SAFETY EVALUATION BY THE OFFICE OF NUCLEAR REACTOR REGULATION

NEDE-32906P, "TRACG APPLICATION FOR ANTICIPATED OPERATIONAL
OCCURRENCES (AOO) TRANSIENT ANALYSES"

GE NUCLEAR ENERGY

PROJECT NO. 710

Figure 1 Comparison of Radial Power Distributions for two Methods used in the Analysis

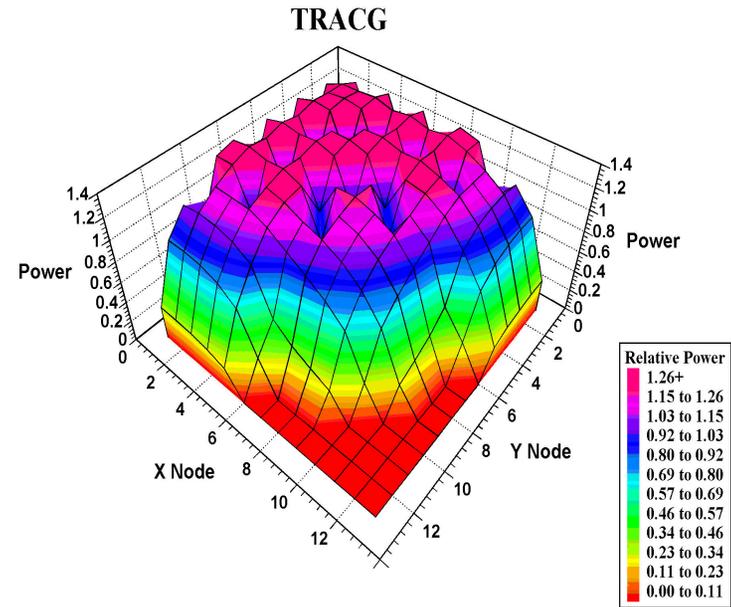
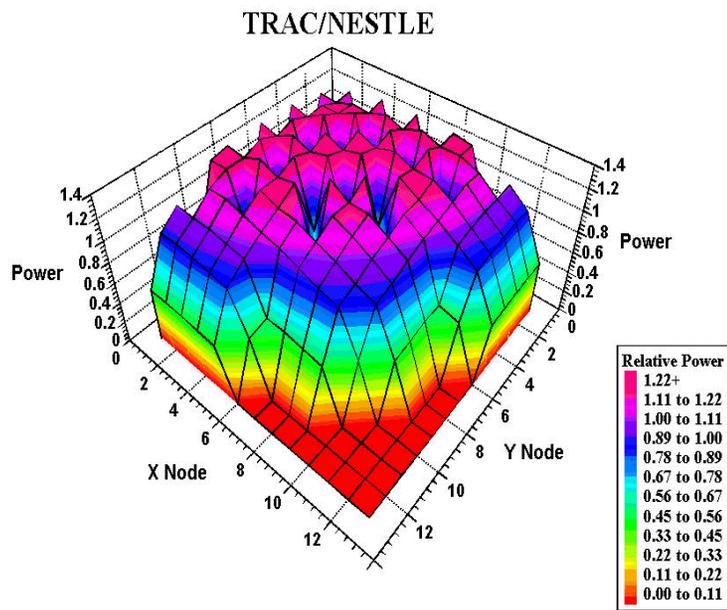
The staff and GNF predictions of the two fuel type core are compared in Figures 1 and 2. Figure 1 shows a three-dimensional view of the initial steady state power distribution and Figure 2 shows the infinite eigenvalue as a function of time for the two fuel types used in the core. One difference between the two predictions in Figure 1 is the fact that the staff results are not as smooth as the GNF analyses. This difference is typical when comparing modern nodal methods to finite difference methods, possibly because nodal methods attempt to more accurately account for inter-assembly gradients. Otherwise, Figure 1 demonstrates that the two methods quantitatively agree well with one another. Figure 2 shows that the void reactivity input into the two respective kinetics codes is equivalent.

Figure 5 Total Reactor Power for Simulated Pressurization Transient

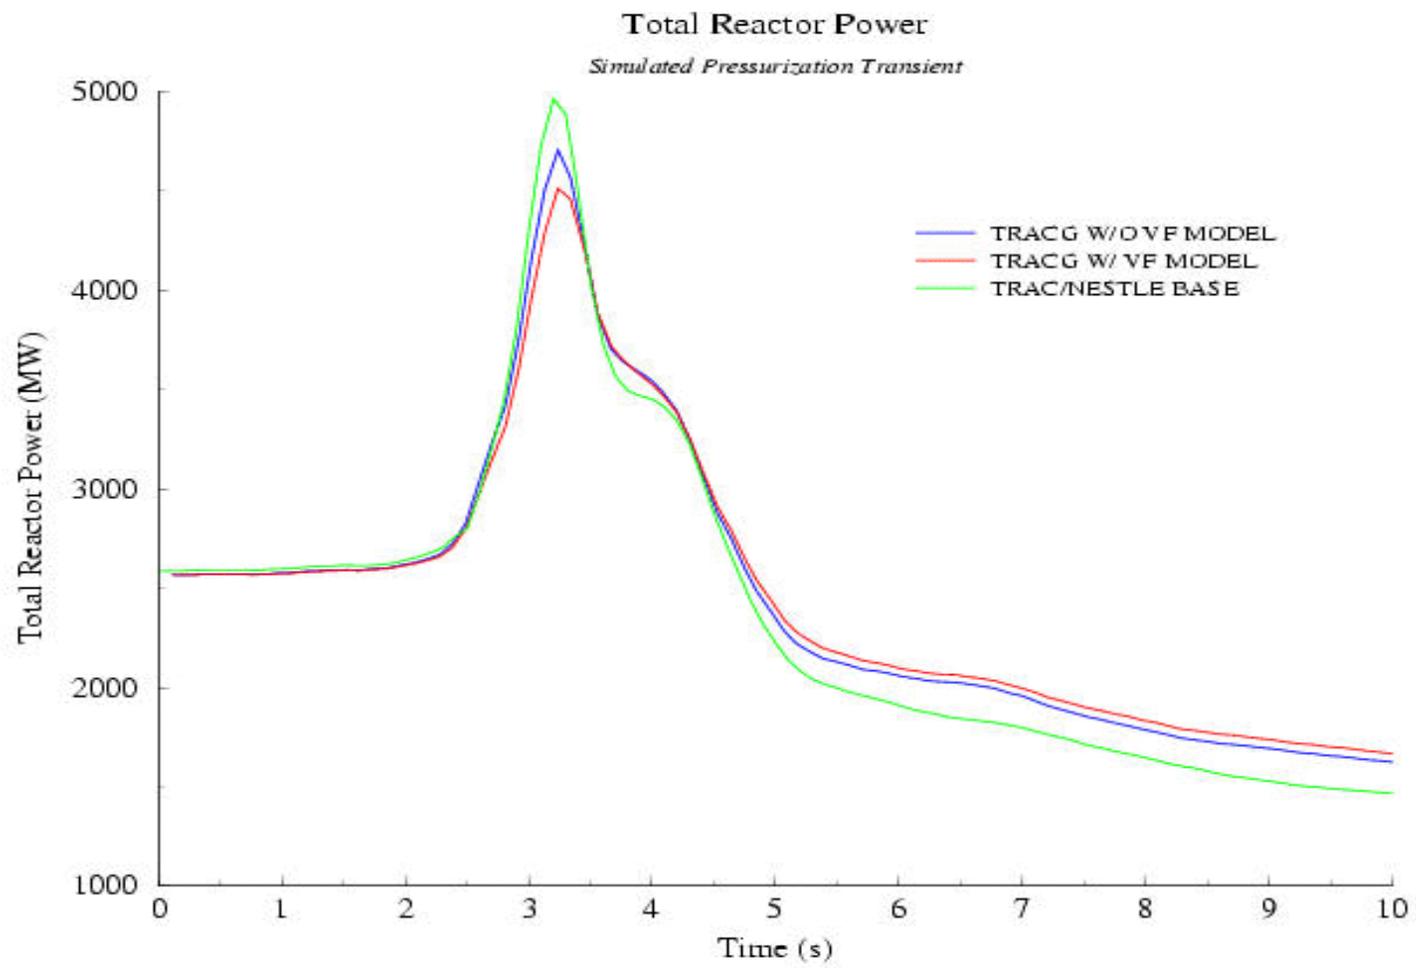
Returning to the discussion of Figure 5, the staff results and the TRACG results are in reasonable agreement. Although the TRACG results without the PIRT18 model agree better with the staff results, the results with the PIRT18 model are acceptable when one considers the following:

1. TRACG compares well with the Peach Bottom turbine trip tests. Although these tests were not as limiting as the transient considered in the test problem and the Peach Bottom core used older BWR fuel that was easier to analyze, the results do provide evidence that TRACG adequately simulates pressurization transients; and
2. The TRACG results, when compared to the staff's results, do not differ significantly enough to affect predictions of Δ CPR/ICPR values. This is true because as mentioned earlier critical power is a function of energy deposition, not power.

Figure 6 Comparison of Different Monte Carlo Evaluations of the Same GNF Lattice

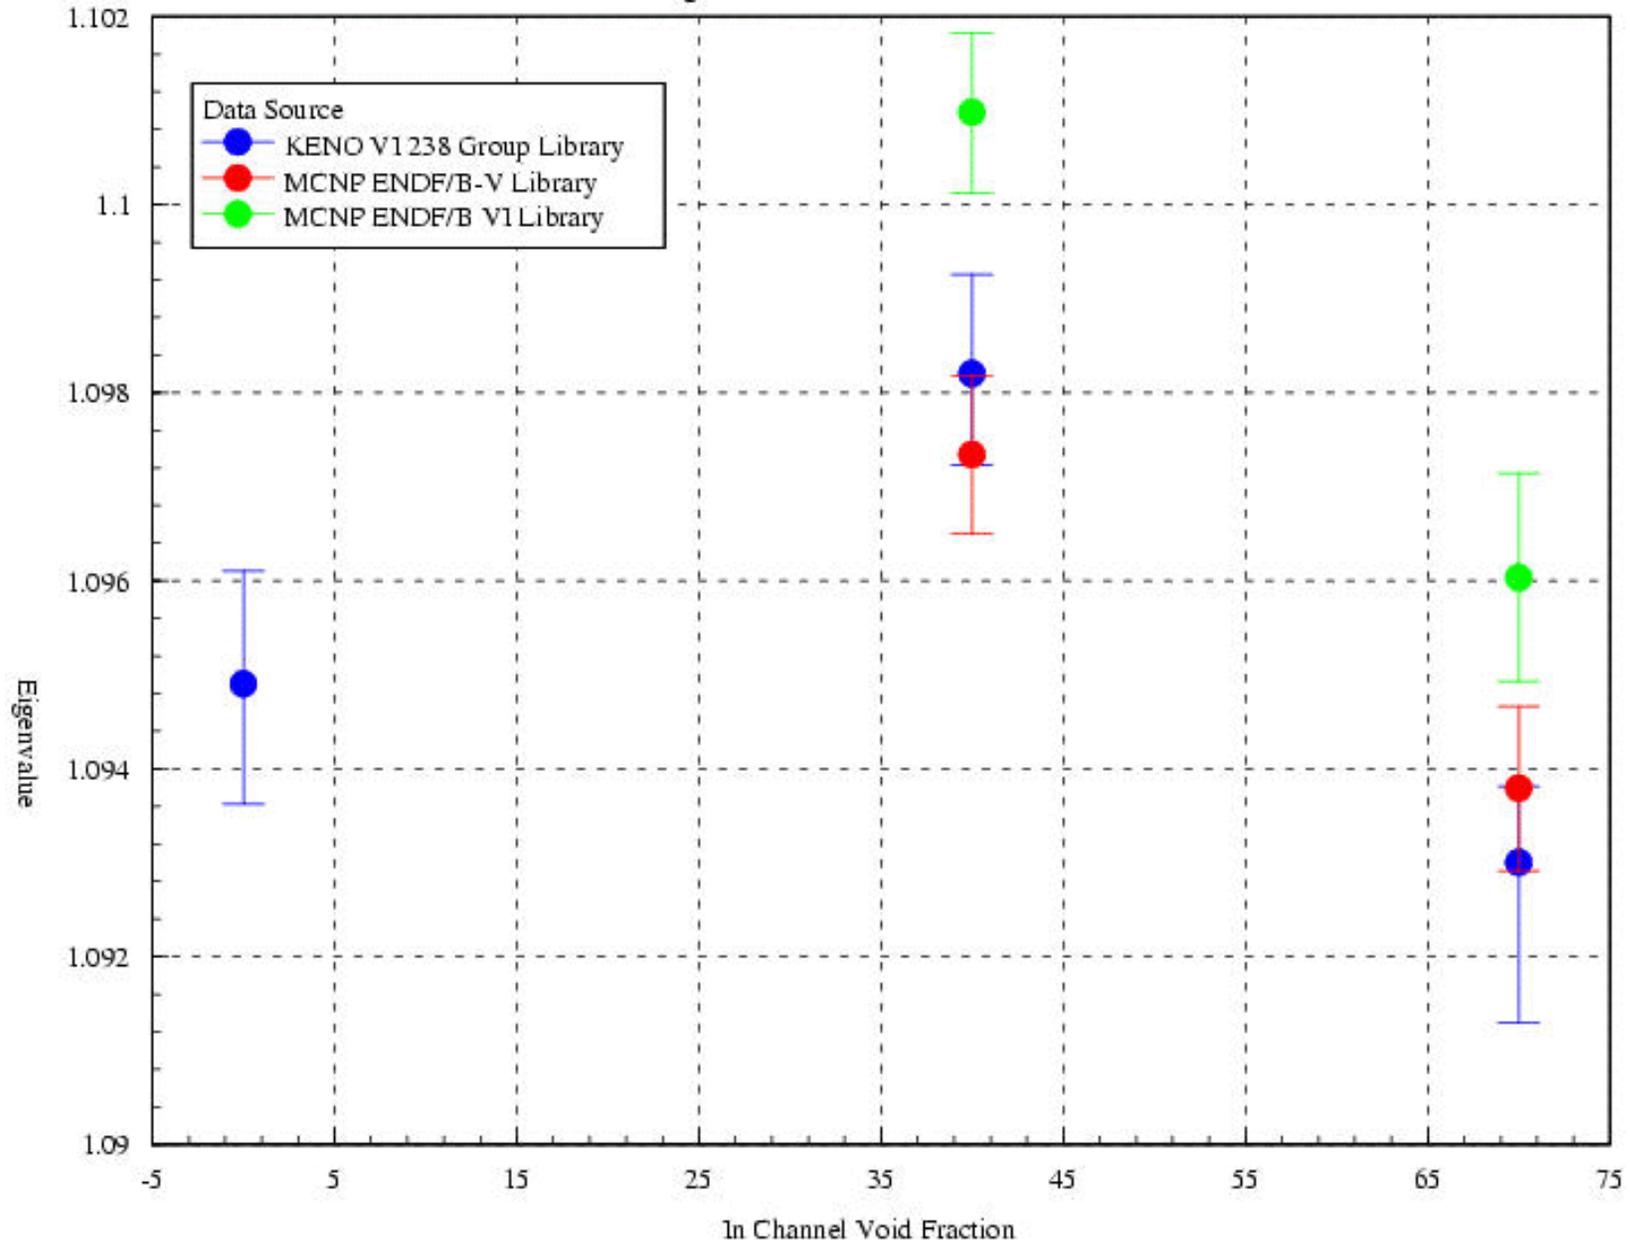
The staff independently assessed this model because the TRACG results are sensitive to it. The staff ran many MCNP calculations of a GNF fuel lattice using different modeling assumptions and different cross sections based on ENDF/B-V and ENDF/B-VI data. The results of the assessment identified a weakness in the GNF model. The GNF model uses the MCNP code, which is a Monte Carlo solver, to predict point values. Monte Carlo methods do not yield point answers; rather, they provide statistically significant ranges of answers. As the staff results in Figure 6 show, a wide range of different, but statistically equivalent answers, can be attained by using different cross section formulations and different (but equivalent) modeling assumptions. The differences presented in Figure 6 would not typically be of concern if it were not for the fact that BWRs are sensitive to void reactivity changes on the order of magnitude of the 95th percentile confidence intervals of the MCNP results.
